Planning and Zoning Commission Meeting

Aubrey City Council Chambers
226 Countryside Dr.
Aubrey, TX 76227
January 8, 2026
6:00 PM

3. Consider and make a recommendation to City Council on a Final Plat application for Lot 1, Block 1, AUB Office Addition. The plat proposes a replat of Lot 82, Block 23, Map of the Town of Aubrey, together with an adjacent triangular tract described in Volume 481, Page 131 of the Deed Records of Denton County, Texas. The property contains approximately 0.557 acres situated within the Dennis Cowan Survey, Abstract No. 304, City of Aubrey, Denton County, Texas. The purpose of the replat is to create a single lot and to dedicate a fire lane easement, water easement, and drainage and detention easement. *(Applicant: SHAP, LLC, 403 S. Main)*
4. Consider and make a recommendation to City Council regarding a Site Plan application for 403 S. Main Street, for office space use within Aubrey city limits. *(Applicant: SHAP, LLC)*

Consider and make a recommendation to City Council regarding a Site Plan application for 403 S. Main Street, for office space use within Aubrey city limits. (*Applicant: SHAP, LLC*)

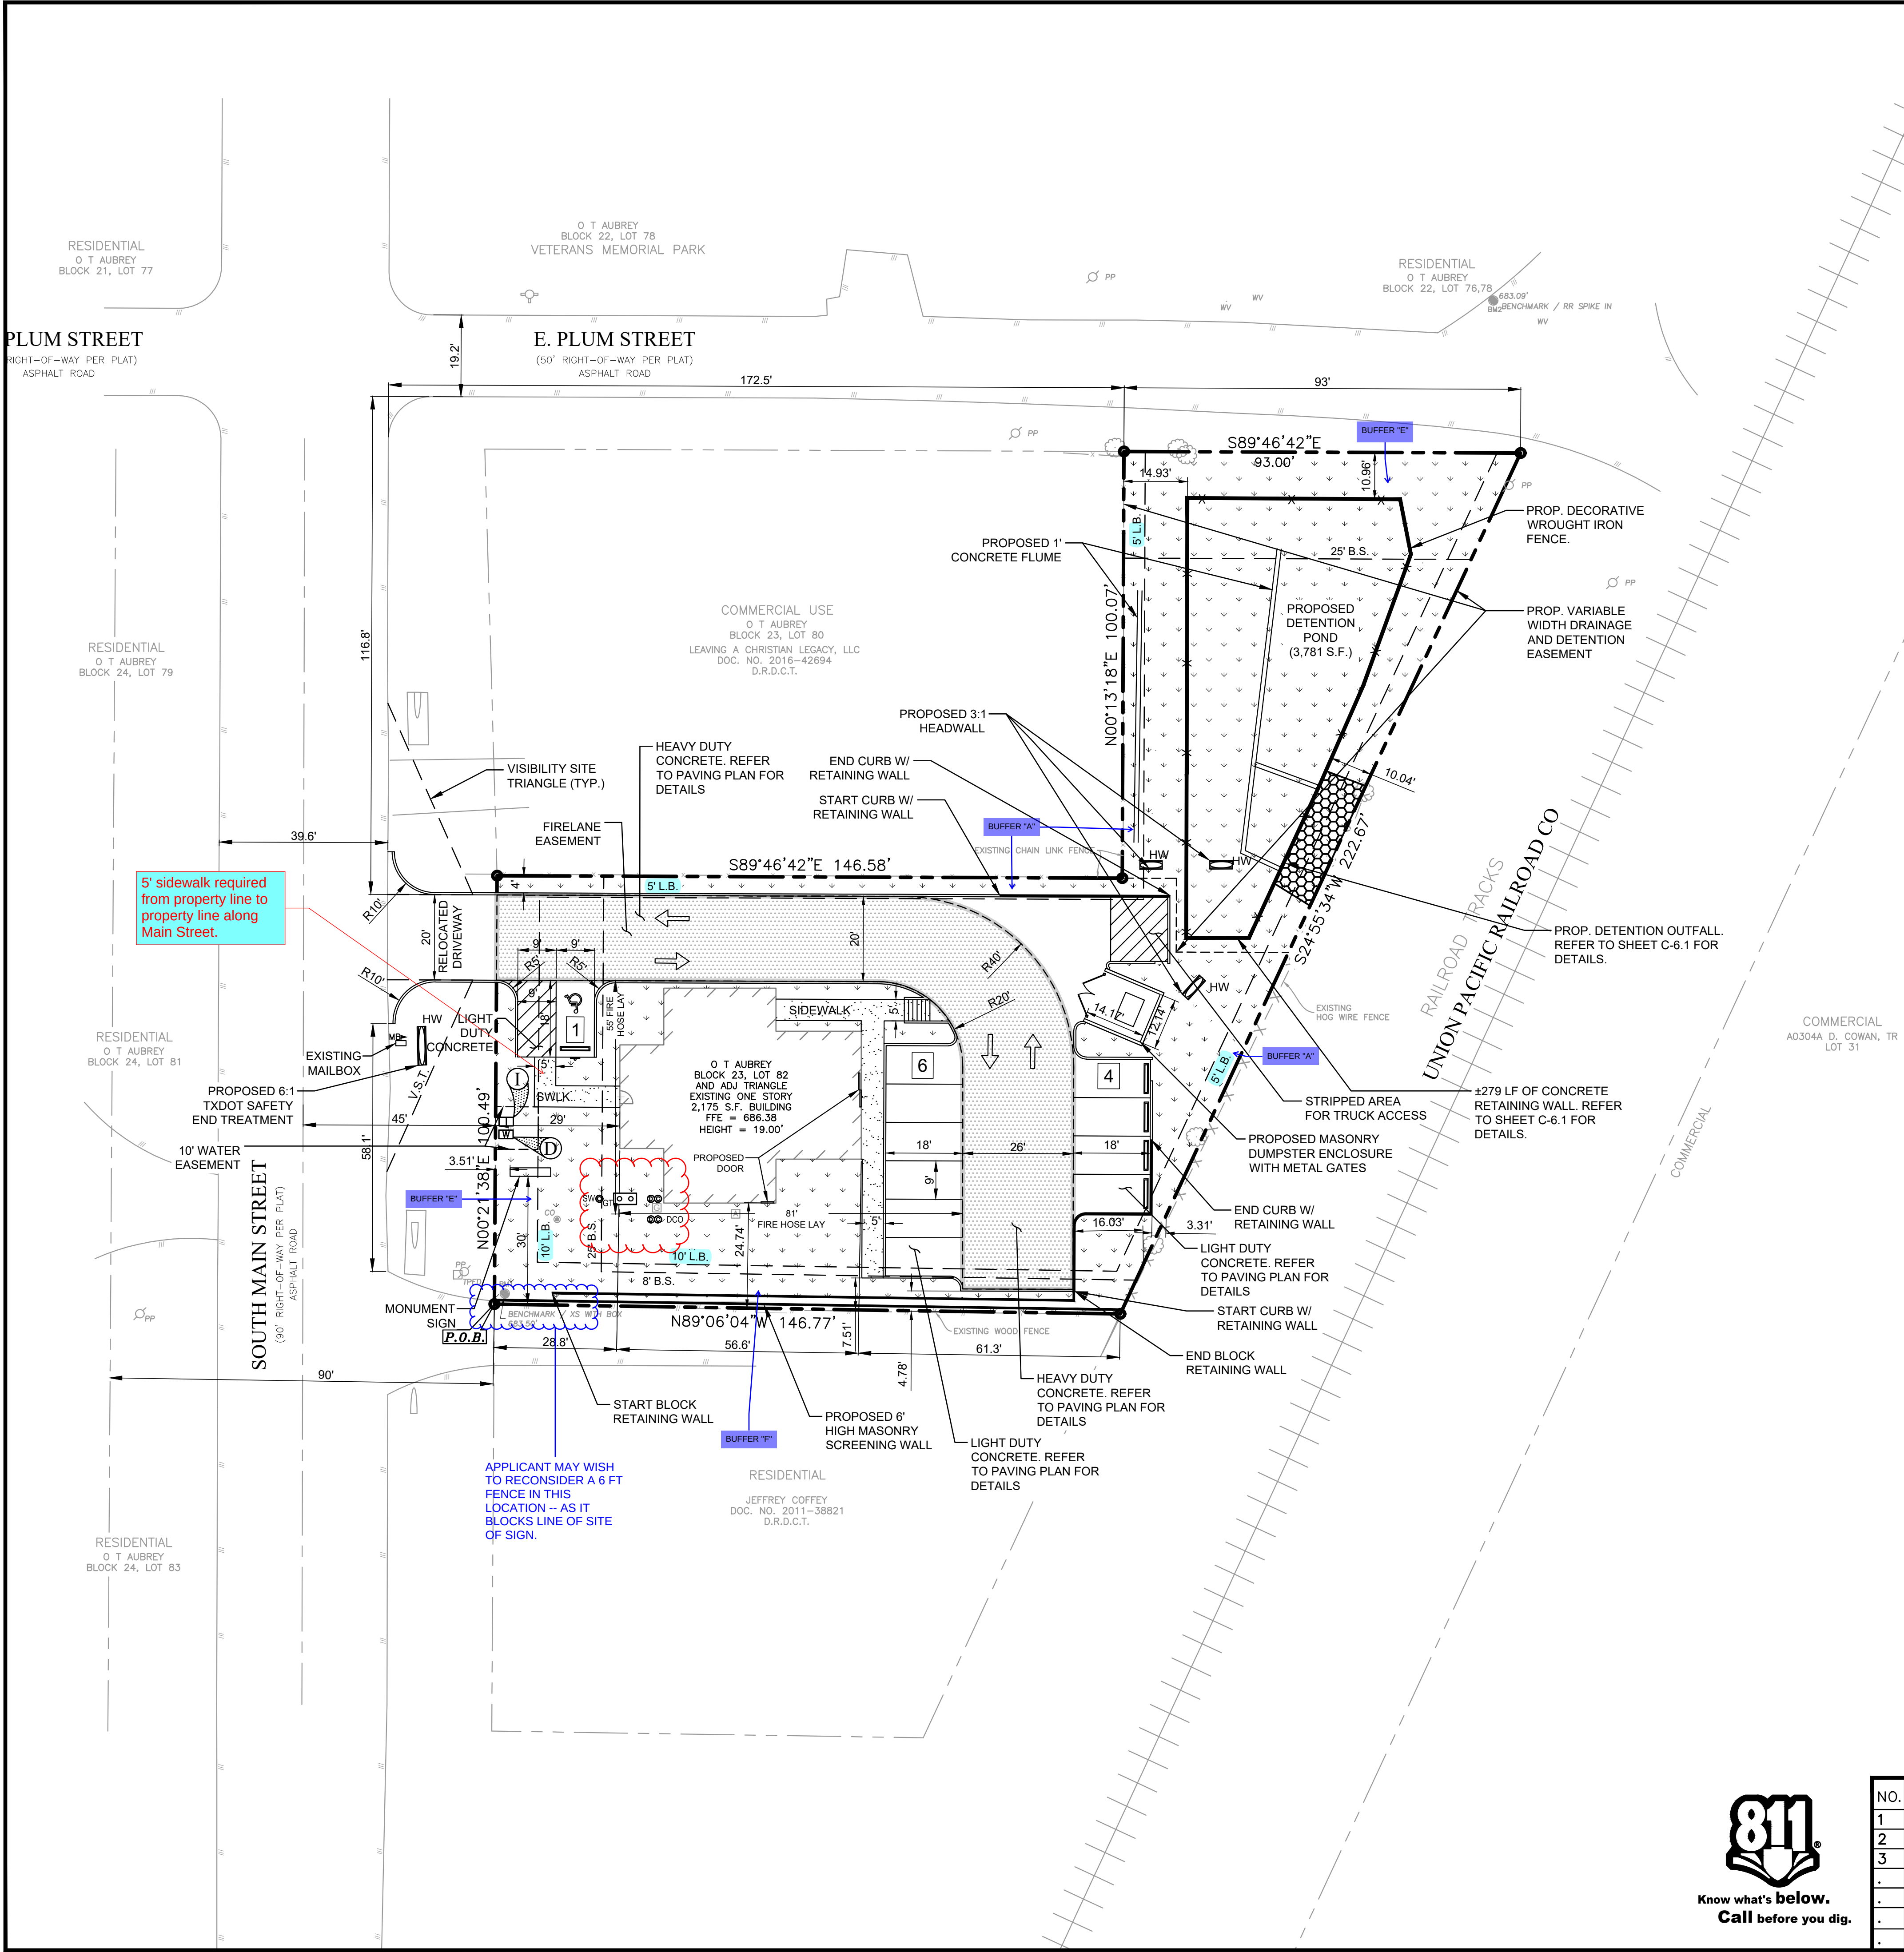
2. **CHAPTER 14; SECTION 23. A.1 (e) (ii).** Part of the requirements for the "E" buffer zone include berms. The design includes the berm along E. Plum Street for the detention pond, but does not include a berm along S. Main Street. The site plan shall be amended to include the required berm. The site plan shall be approved by the Development Manager prior to issuance of a building permit.

SHEET NAME:
TREE REMOVAL PLAN

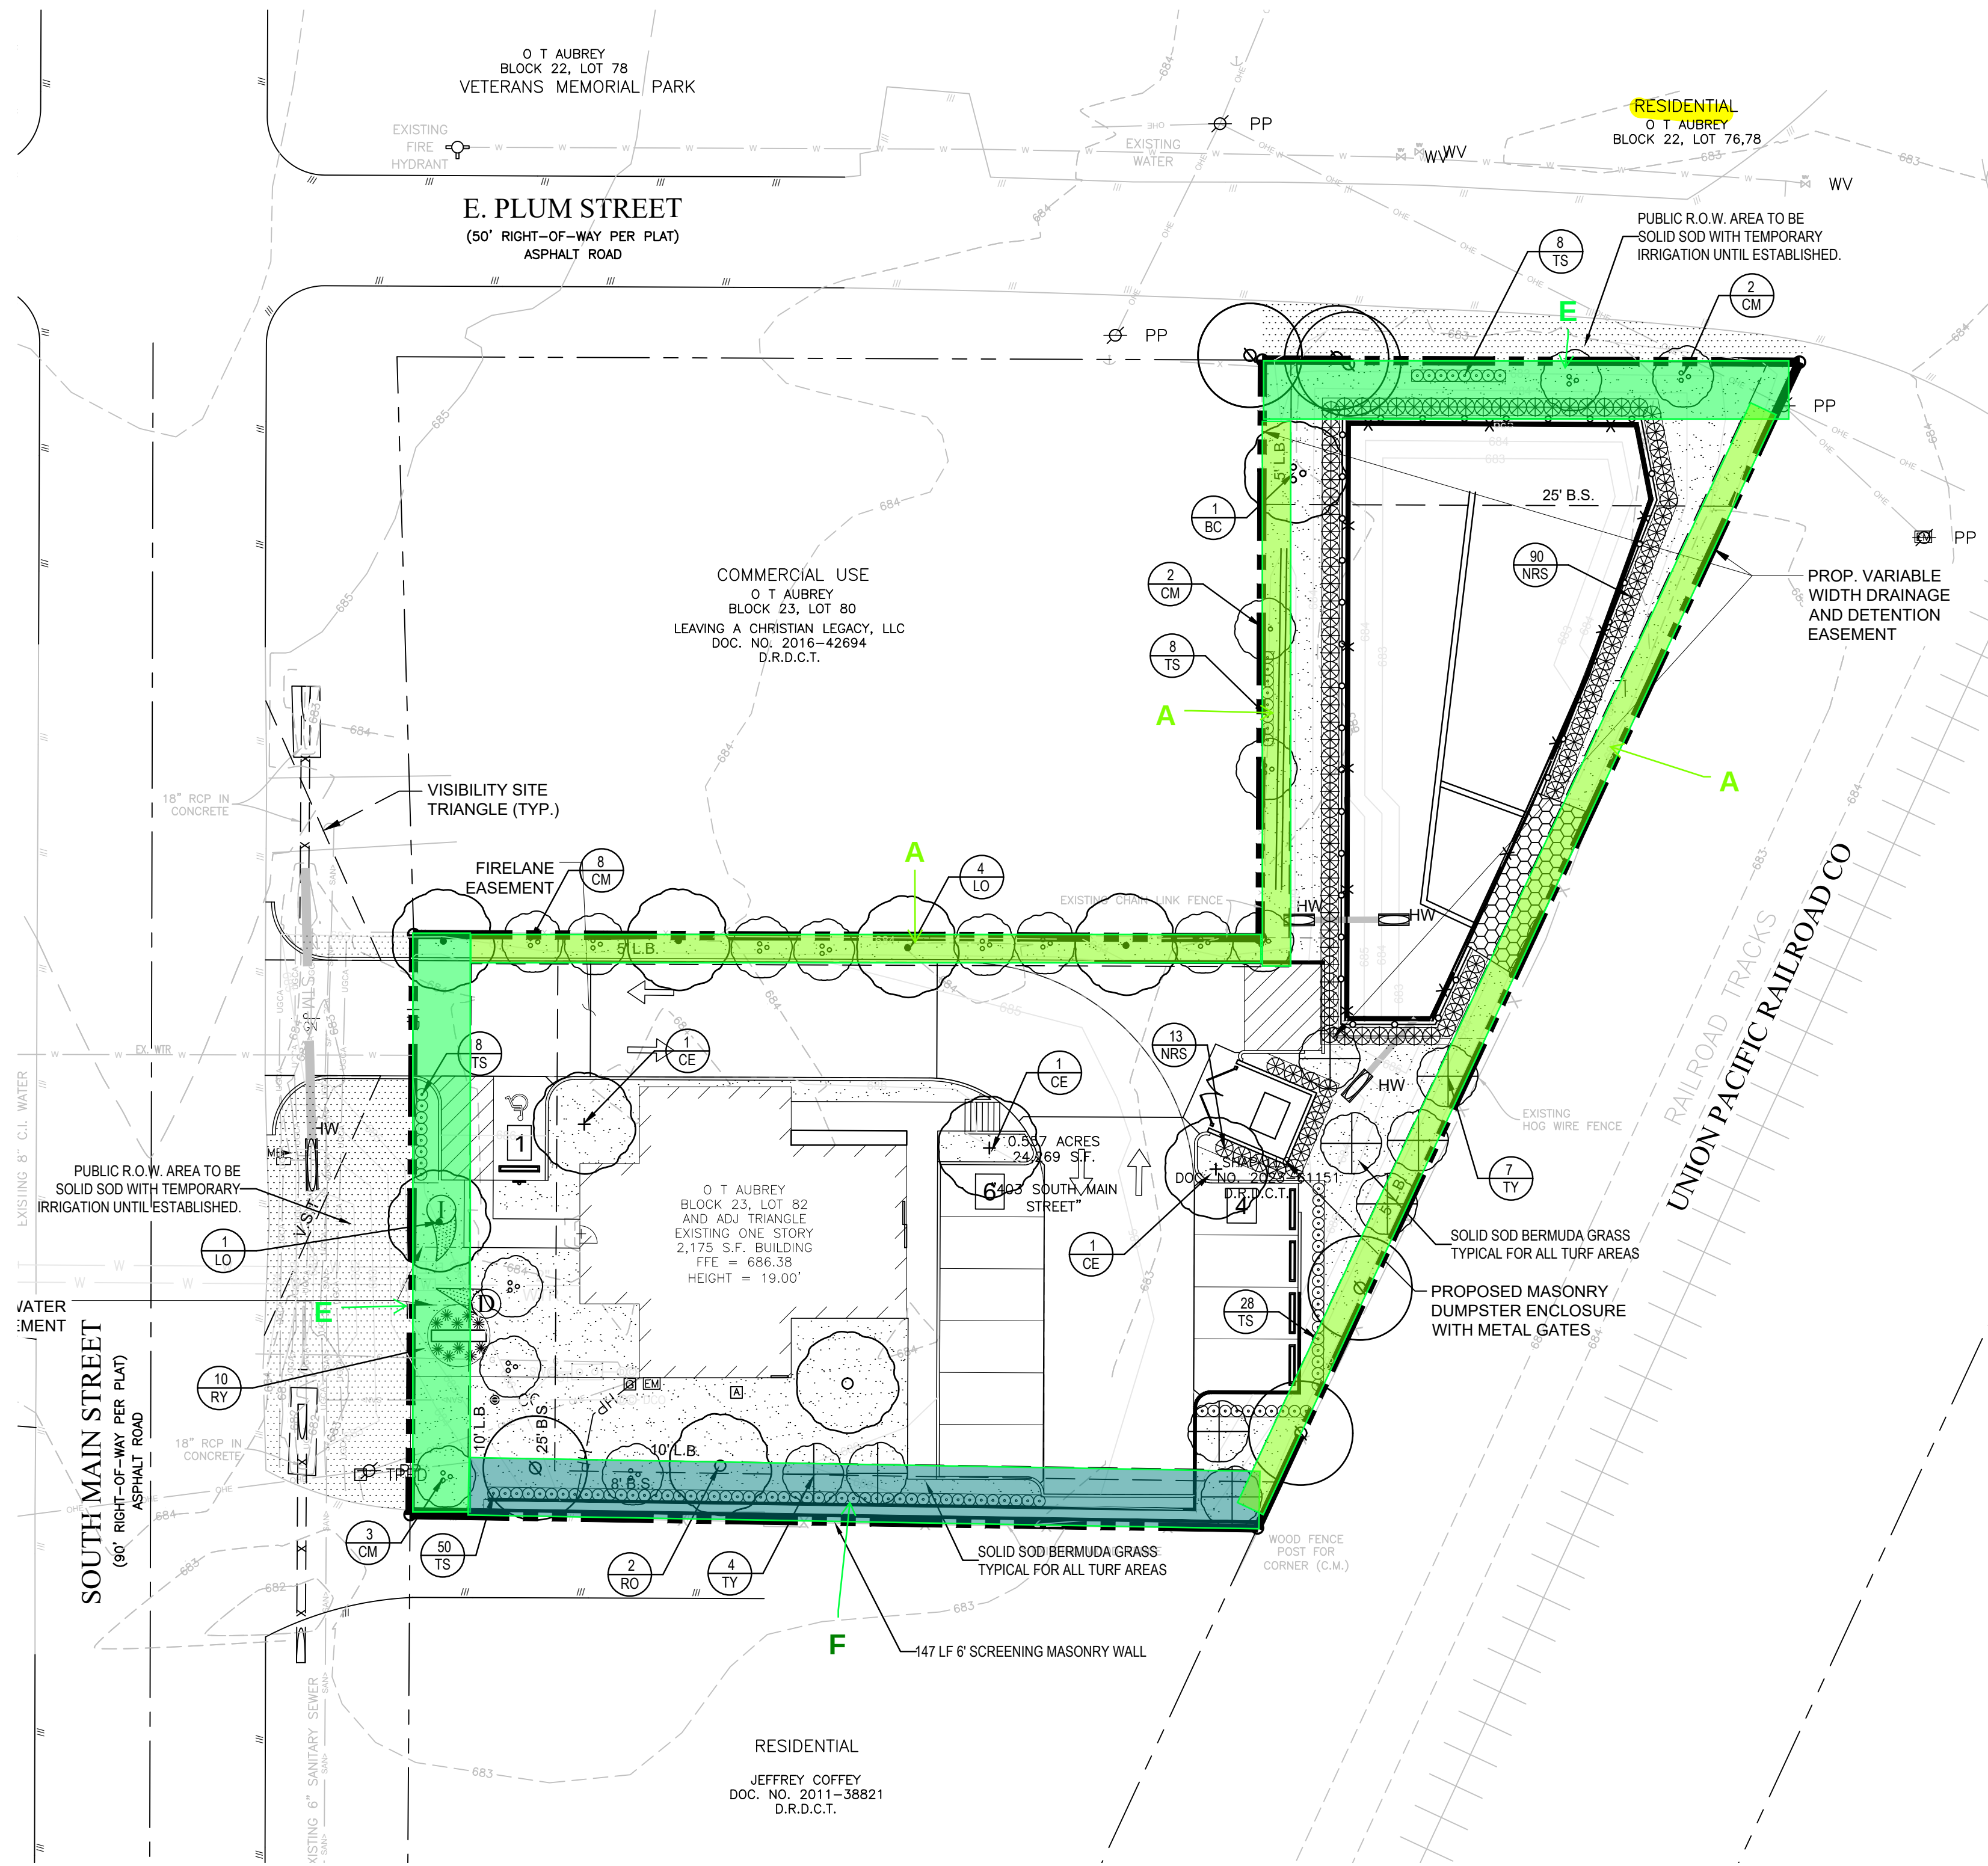
1. **CHAPTER 14; SECTION 23. G.1 (i) — NONRESIDENTIAL LANDSCAPE REQUIREMENTS.** The intent of the nonresidential landscape requirements is for the protection of healthy trees and vegetation and promoting the natural ecological, environmental, and aesthetic qualities of the city. This plan lacks tree preservation. This lot has many existing trees from 8" inches to 32" inches in diameter. The landscape plan shall be amended to include some preservation. The landscape plan shall be approved by the Development Manager prior to issuance of a building permit.
